Building Inspection Report

Inspection Date: Sat, 10 Jan 2026

Property Address: 39 Monakeeba Bvd, WOODSTOCK, VIC,
3751, Australia

Defects 3.04

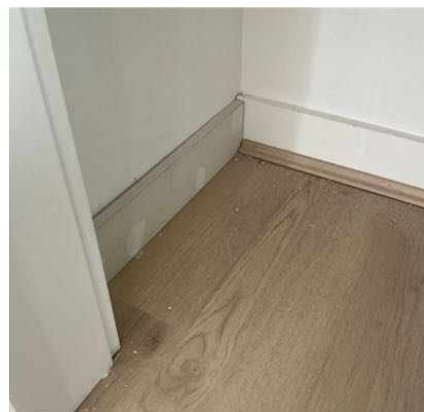
Building:	Main Building
Location:	All Internal Areas
Finding:	Incomplete Internal Painting - PCI
Information:	During the inspection, areas of incomplete painting were observed to various internal surfaces throughout the property. These include locations where paint has been entirely missed or cut short, particularly around corners, edges, trims, and junctions. The defects indicate that painting works have not been fully completed at the time of inspection.

Incomplete painting presents an unfinished appearance and may leave surfaces exposed to potential wear or moisture effects. Repainting is required in the affected areas to ensure full coverage and compliance with applicable standards. Photos provided serve as examples and may not capture all areas requiring attention.

Defects 3.05

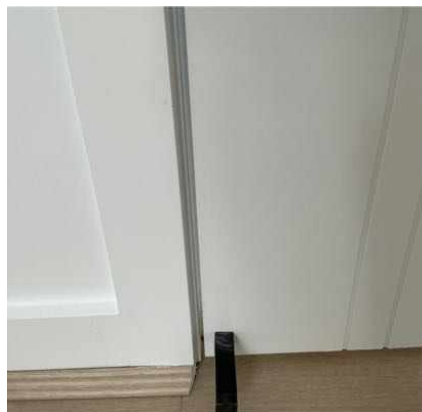
Building:	Main Building
Location:	All Internal Areas
Finding:	Inconsistent Door Margins – Non-Compliant Installation - Fix/PCI
Information:	During inspection, the door unit was observed to have inconsistent margin gaps between the door leaf and the surrounding frame and architraves. Visible irregularities were present along the top, sides, and bottom edges, with clearances varying beyond acceptable tolerances. These discrepancies not only detract from the visual presentation but may also interfere with the operation of the door, including risks of binding or hardware misalignment during use.

Rectification is required to ensure compliance.

Defects 3.12

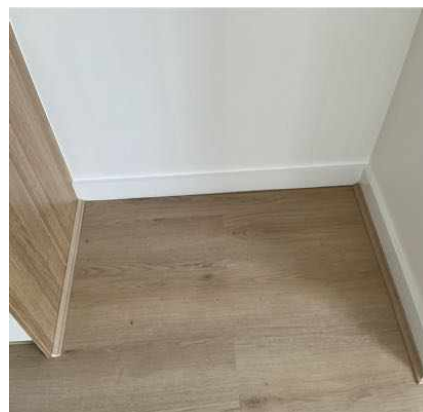
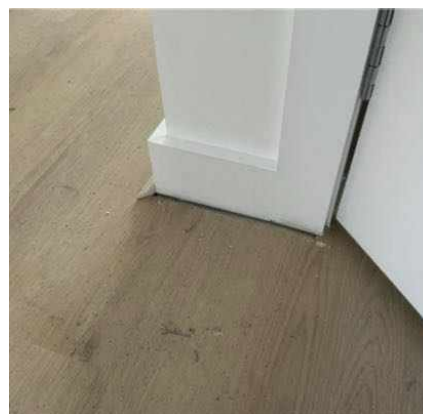
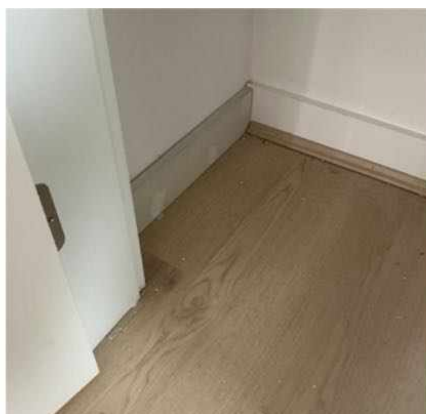
Building:	Main Building
Location:	Internal Areas
Finding:	Floating Floor Trim Not Installed in One or More Areas - PCI
Information:	At the time of inspection, it was noted that sections of the floating floor trim have not been installed or securely fixed in one or more areas. These trims are either missing or left loose, leaving an incomplete finish at floor junctions. This does not meet the required standard of workmanship and leaves the flooring installation vulnerable to movement, lifting, or damage during normal use.

The current condition is non-compliant. All floating floor trims must be properly installed and secured to provide a complete, durable, and workmanlike finish. Rectification is required to ensure compliance.

Defects 3.13

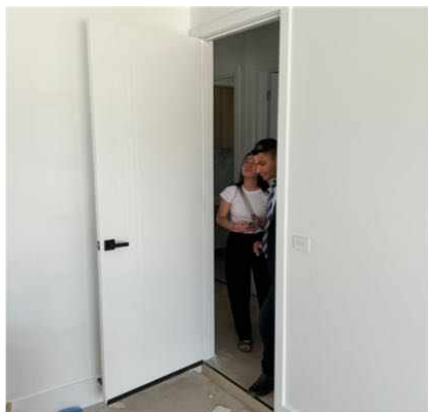
Building:	Main Building
Location:	Internal Garage Access Door
Finding:	Missing Door Seals to External Openings - PCI
Information:	During the inspection, it was noted that required door seals were not installed to one or more external door openings. Door seals play a critical role in preventing water ingress, air leakage, dust intrusion, and thermal loss. They are also essential for ensuring compliance with energy efficiency requirements and maintaining the weatherproofing performance of the building envelope.

The absence of appropriate seals does not comply with the minimum requirements set out in the NCC and Australian Standards. All external doors must be fitted with compliant seals in accordance with manufacturer specifications to maintain performance, energy rating compliance, and long-term durability.

Defects 3.15

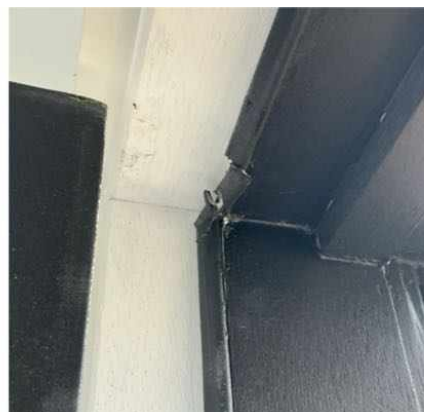
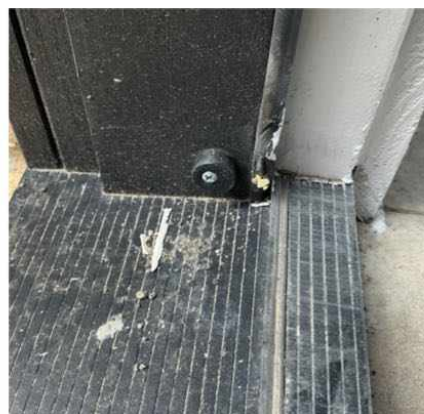
Building: Main Building
Location: Rear Garage Door
Finding: Damaged, Paint-Contaminated and/or Poorly Installed Door Seals - PCI
Information: The door seals installed to various door frames throughout the dwelling have been observed to be contaminated with paint, poorly installed and/or physically damaged. This typically occurs when seals are not removed or adequately protected during painting works, leading to reduced flexibility, poor compression, and impaired sealing performance.

The current condition is non-compliant. All affected door seals must be cleaned or replaced in accordance with the manufacturer's guidelines to restore full performance and maintain compliance.

Defects 3.16

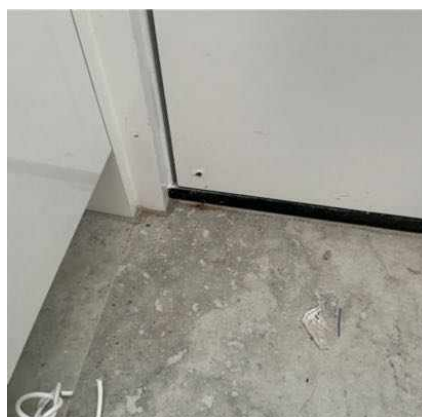
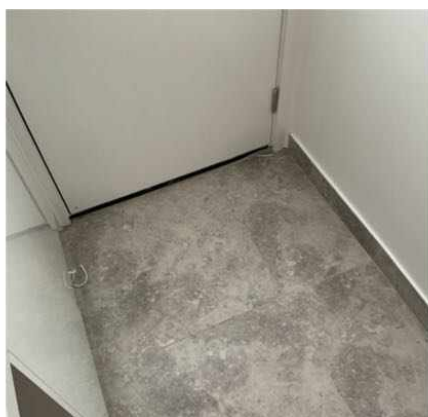
Building:	Main Building
Location:	Laundry
Finding:	Missing Door Stop – Internal Door - PCI
Information:	During the inspection, a door stop was found to be missing from an internal door location. In the absence of a functioning door stop, the door is left vulnerable to contact damage from walls or adjacent surfaces when opened fully. This presents a risk of avoidable impact damage to both the door and surrounding finishes.

The absence of a door stop does not meet the expected standard of internal fit-off and leaves building elements at risk of damage. Installation of a compliant door stop is required to ensure appropriate protection of finishes and to achieve a complete and

Defects 3.17

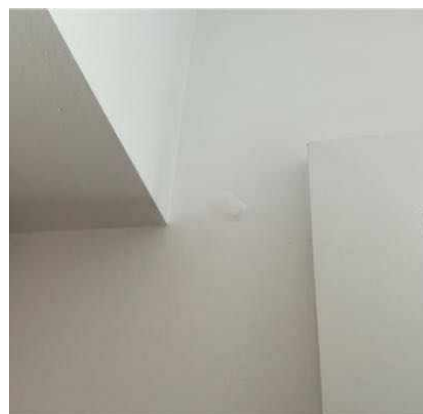
Building:	Main Building
Location:	Laundry & Fridge Recess
Finding:	Substandard Plasterwork Failing to Meet Level 4 Finish - PCI
Information:	The plasterwork throughout the dwelling displays a range of surface defects, including visible swirls, dents, creases, pinholes, sanding marks, and poorly finished joints. These imperfections are inconsistent with the required Level 4 finish and significantly detract from the visual quality and expected presentation of new construction.

The current condition is non-compliant. All affected plasterboard surfaces must be re-skimmed, patched, or otherwise refinished to eliminate visible imperfections and achieve a true Level 4 finish. While the photos provided highlight selected examples, a full review of all internal wall and ceiling surfaces is recommended to ensure uniform quality and compliance prior to painting and final handover.

Defects 3.18

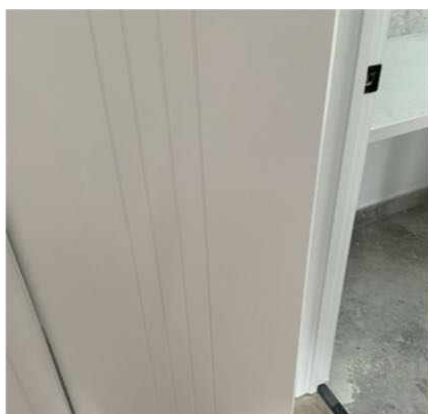
Building:	Main Building
Location:	Storage Cupboard
Finding:	Missing Door Handle and Door Catch Installation
Information:	During the inspection, it was observed that a door has not been fitted with a handle and no door catch or latch mechanism has been installed. As a result, the door cannot be properly operated, secured, or retained in the closed position. This condition represents an incomplete installation and prevents the door from functioning as intended.

Rectification is required to ensure the door is fitted with appropriate handle and door catch hardware so that it operates correctly, safely, and in accordance with applicable standards.

Defects 3.19

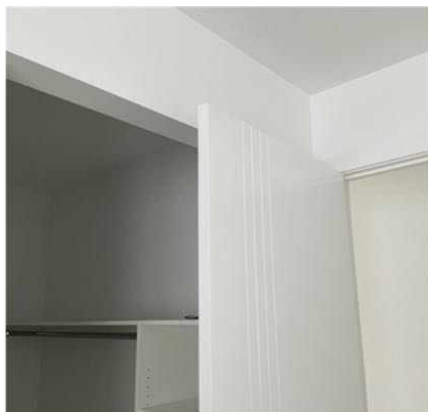
Building:	Main Building
Location:	Bedroom
Finding:	Excessive Paint Application - Paint Runs - PCI
Information:	Paint runs were observed on internal surfaces. These occur where paint has been applied too heavily without being properly levelled, resulting in visible streaking or raised surface irregularities. The finish does not meet the required standard of workmanship for new construction.

Rectification is required to ensure compliance. While selected examples have been photographed, a full inspection of all painted surfaces is recommended to ensure all imperfections are identified and addressed.

Defects 3.21

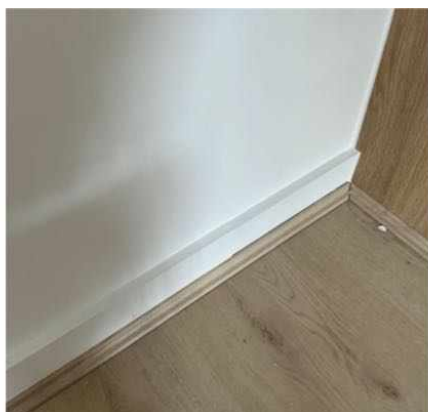
Building: Main Building
Location: Kitchen Bench
Finding: Poor Skirting Board Join – Butt Joint Used Instead of Mitre Joint
Information: During the inspection, a poorly finished joint was observed to the skirting board. The joint has been formed as a butt joint rather than a mitred joint, resulting in a visible and uneven junction. The joint is not flush, is visually apparent from a normal standing position, and detracts from the overall quality of the internal finish.

Mitred joints are standard trade practice for skirting board terminations as they provide a tighter, neater, and more durable finish. Butt joints are prone to opening, cracking, and becoming visually inconsistent over time due to timber movement and shrinkage.

Defects 3.34

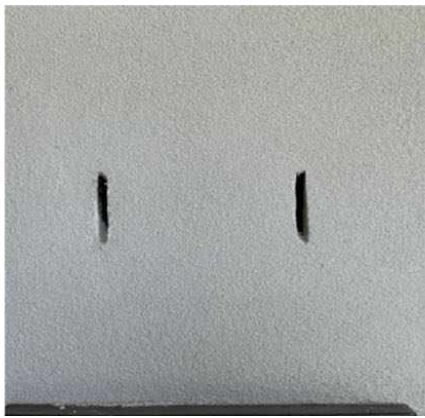
Building: Main Building
Location: All External Areas
Finding: Obstructed Weep Holes to External Masonry Walls - PCI
Information: At the time of inspection, multiple weep holes to the external masonry walls were observed to be partially or fully obstructed by applied render, coating finishes, and/or mortar. The obstruction prevents the weep holes from performing their intended function of allowing moisture to drain from the cavity and providing ventilation behind the masonry veneer. This condition was noted at several locations and is inconsistent with acceptable construction practice for masonry wall systems.
Reference:

Defects 3.37

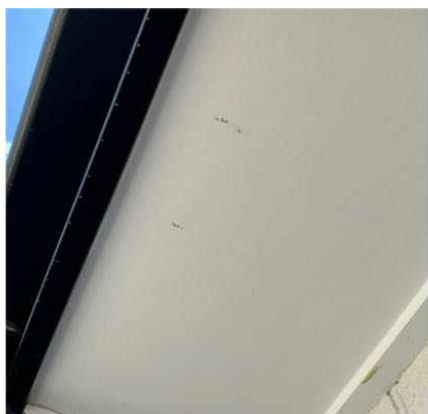
Finding: Incomplete External Painting - PCI

Information: During the inspection, it was observed that the external painting of the property had not been completed in several areas, including sections of the façade, trims, and other external elements. These areas present with missing or partial paint coverage, which detracts from the property's appearance and fails to provide adequate protection from weather exposure.

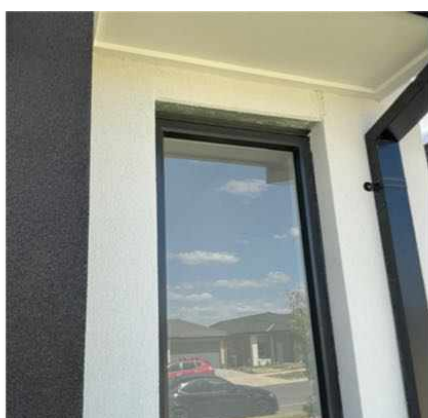
Building:	Main Building
Location:	Front Window
Finding:	Unpainted External Galvanised Brick Lintels - PCI
Information:	During the inspection, external galvanised steel brick lintels were observed to be left unpainted. While galvanising provides an initial level of corrosion resistance, it does not provide long-term protection when exposed to weather, moisture, and airborne contaminants. Without a protective paint system, galvanised lintels are susceptible to surface breakdown, white rust formation, and eventual corrosion, which can lead to staining of masonry and deterioration of the lintel over time.

Rectification is required to ensure the lintels are correctly prepared and painted with an appropriate protective coating system, including suitable surface preparation and priming for galvanised steel, to provide long-term corrosion protection and ensure compliance with durability and performance requirements.
